# COMAL COUNTY

### License to Operate On-Site Sewage Treatment and Disposal Facility

Issued This Date: 03/06/2025 Permit Number: 116271

### **Permit of Authorization to Construct an On-Site Sewage Facility Permit Valid For One Year From Date Issued**

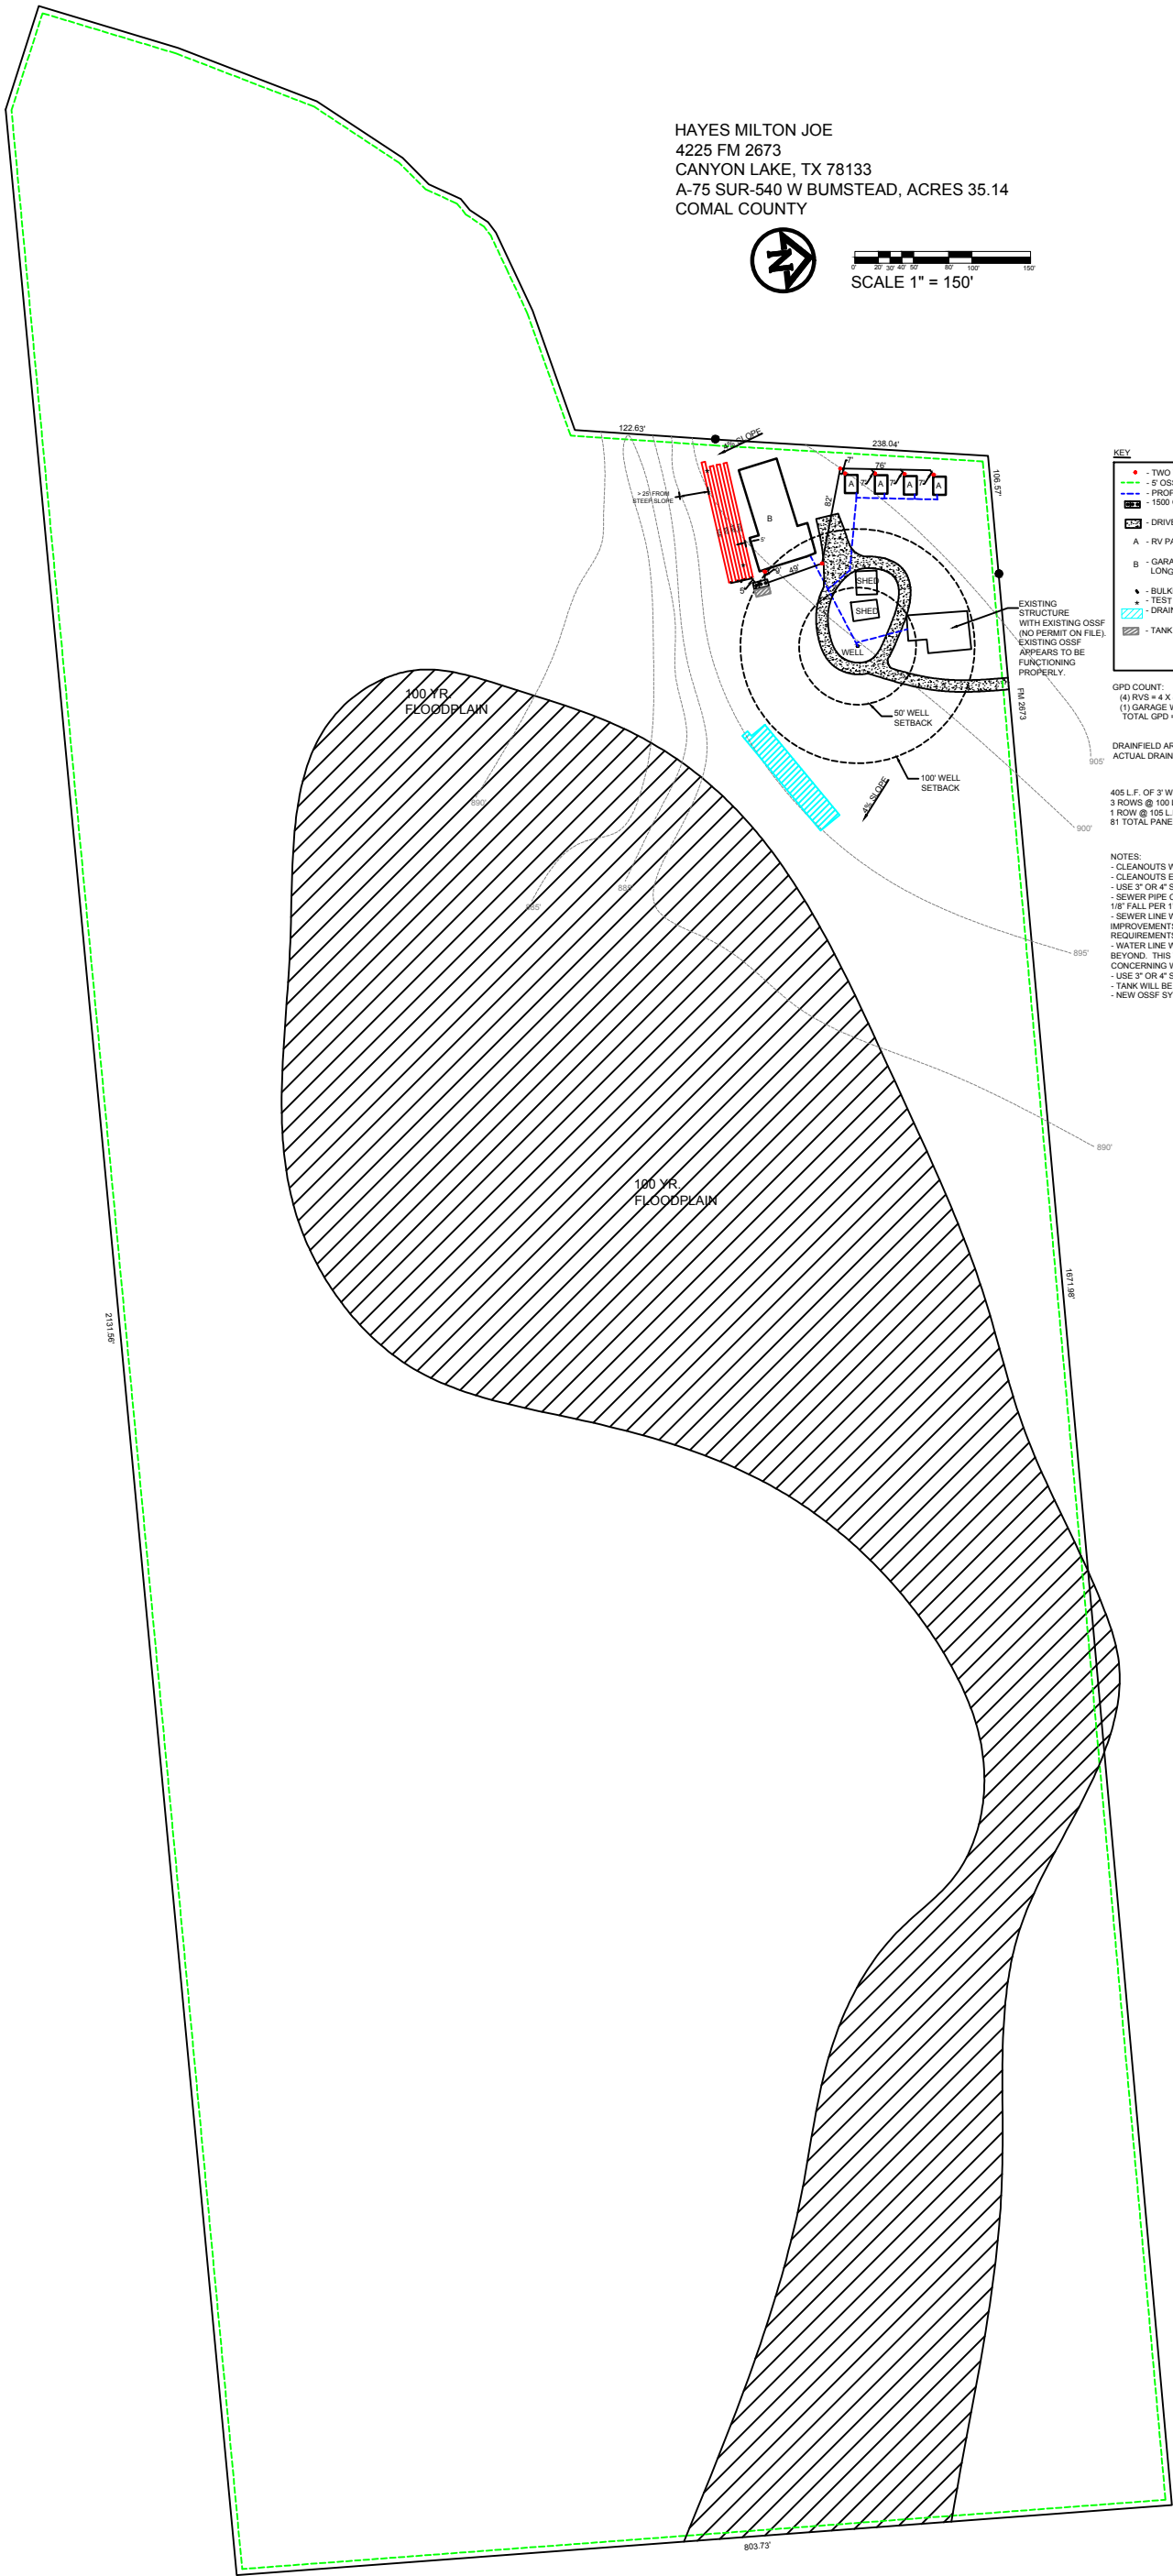
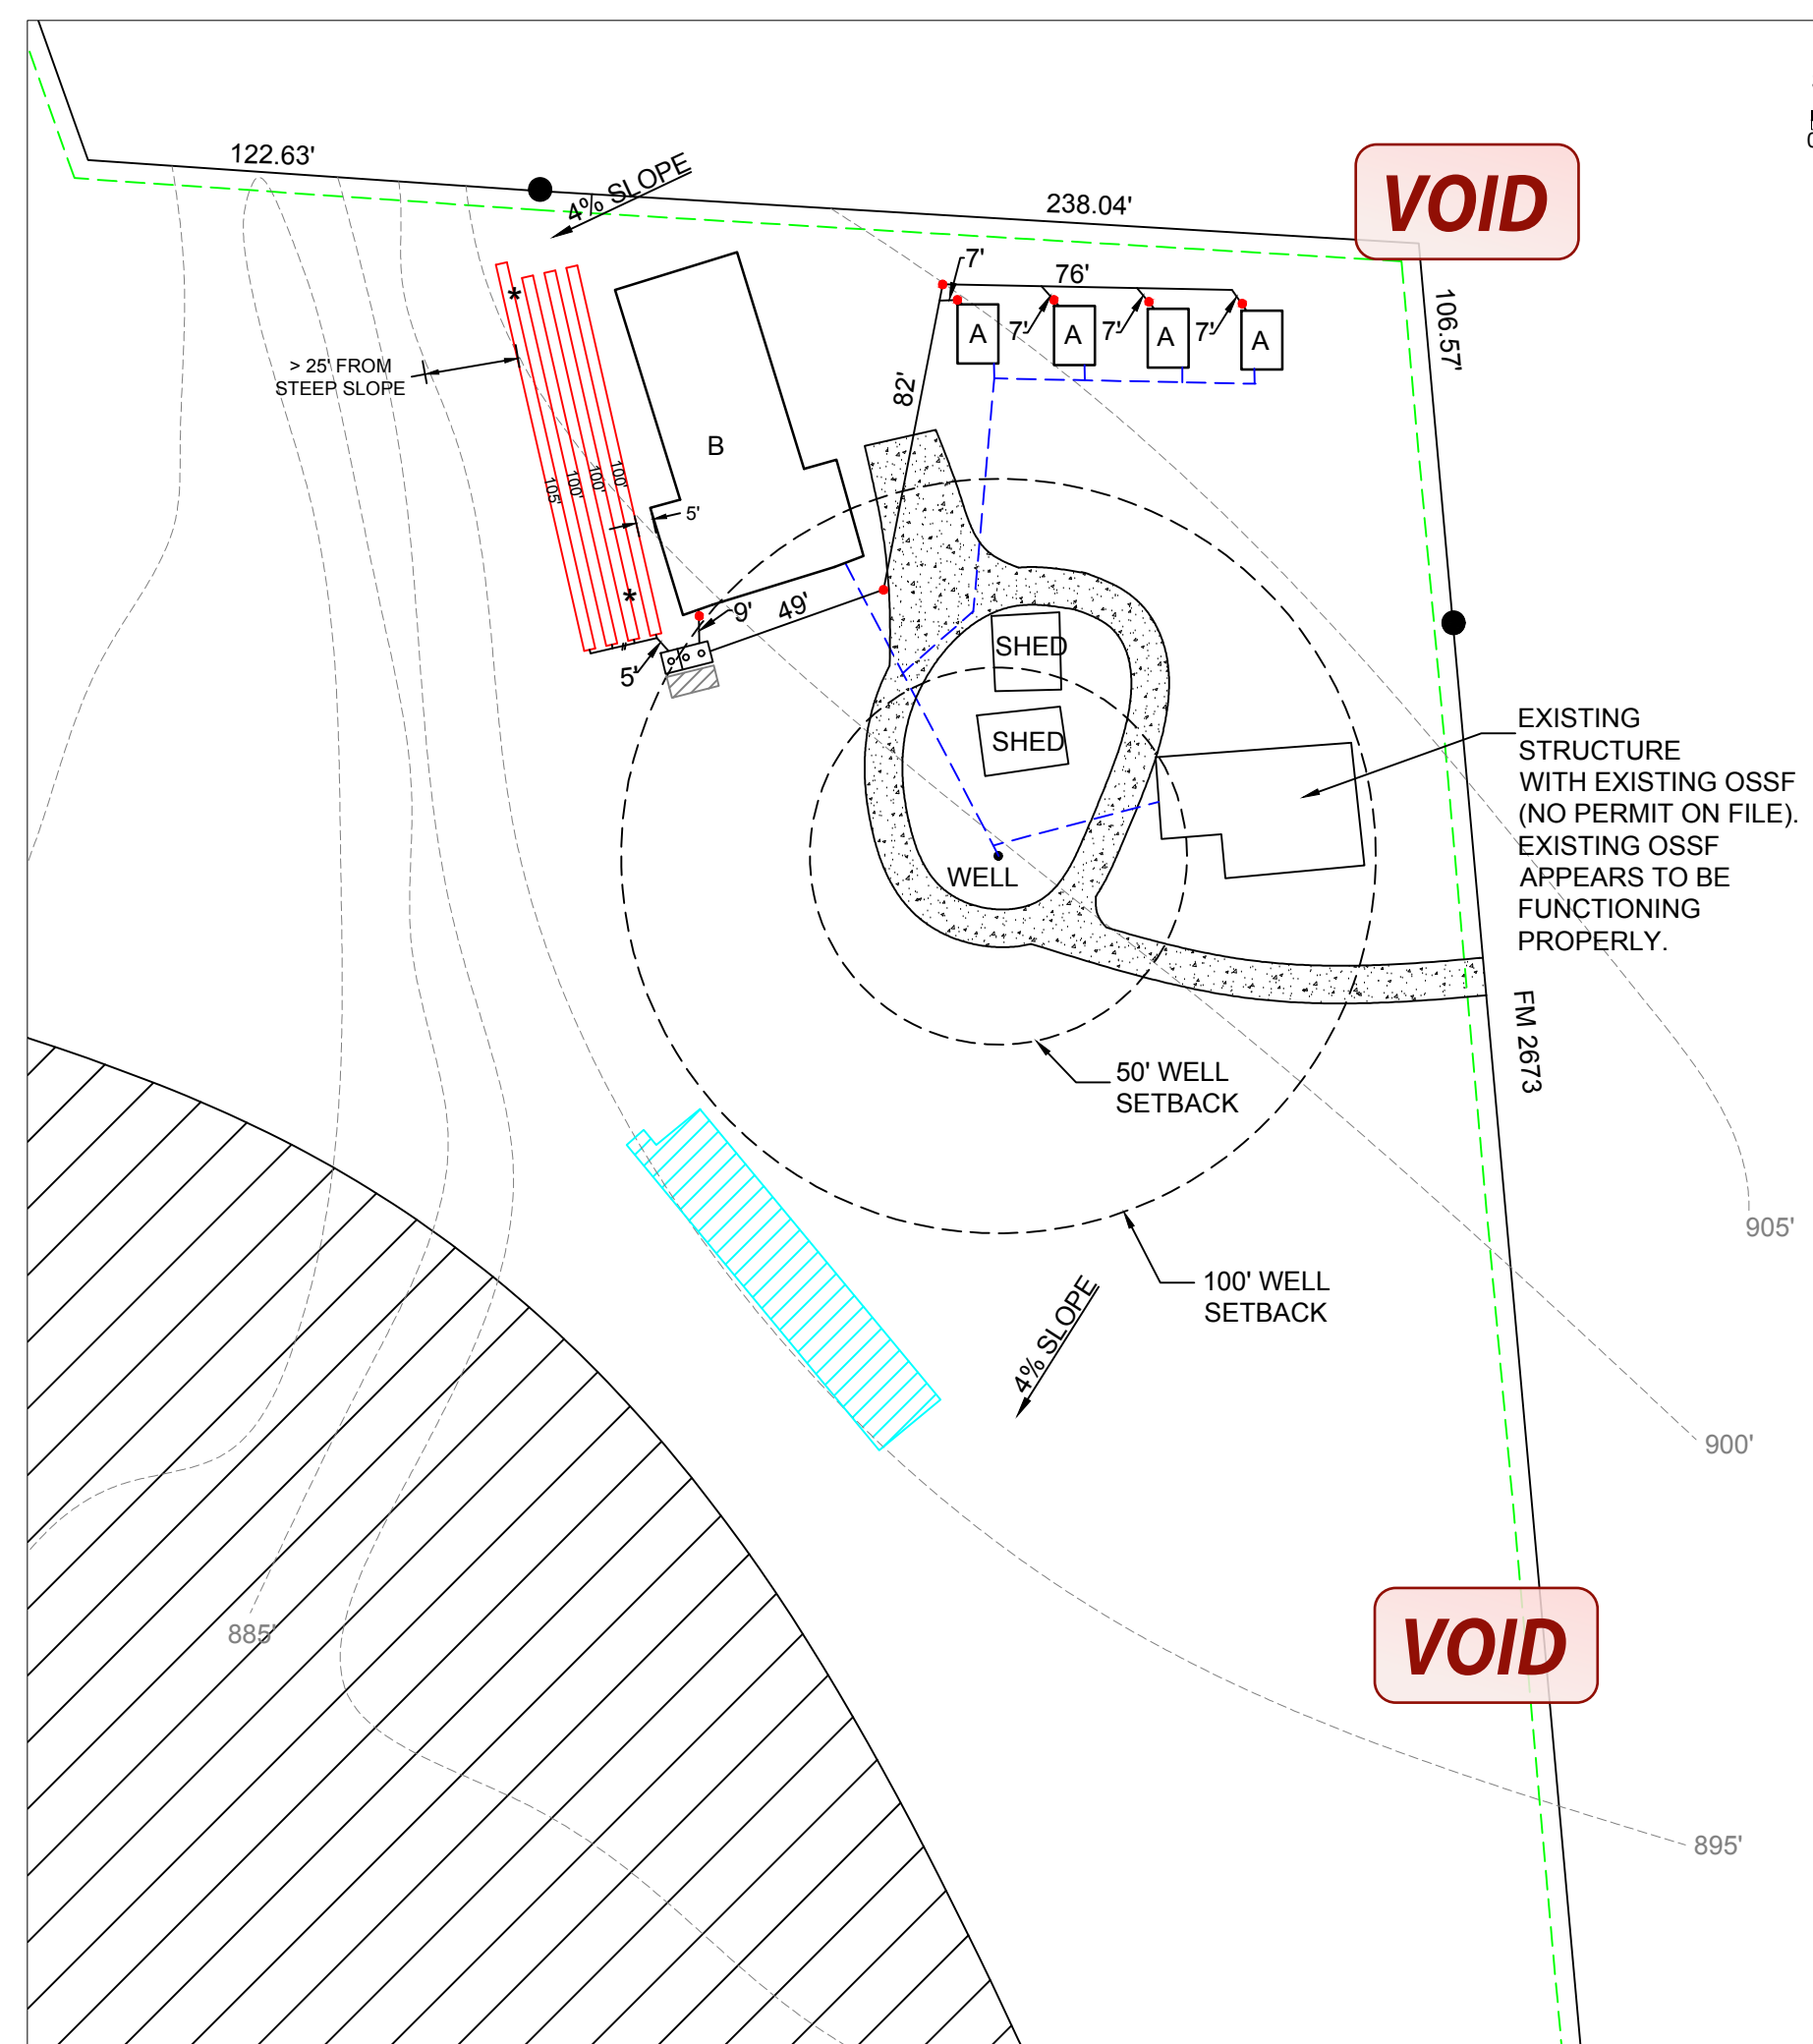
1.  Verify of the existing home with the existing septic system is the same home that was built in 1912. Also, verify if there have been any alterations to the home or the septic system since September 1<sup>st</sup>, 1989.
-  The 4 RV's are considered high strength wastewater. Submit BOD calculations from a Professional Engineer.
-  As per the attached guidance, once all information is received this permit will be submitted to TCEQ for their review.
4. Revise as needed and resubmit.

Please see attached revised plans removing any mention of RVs.
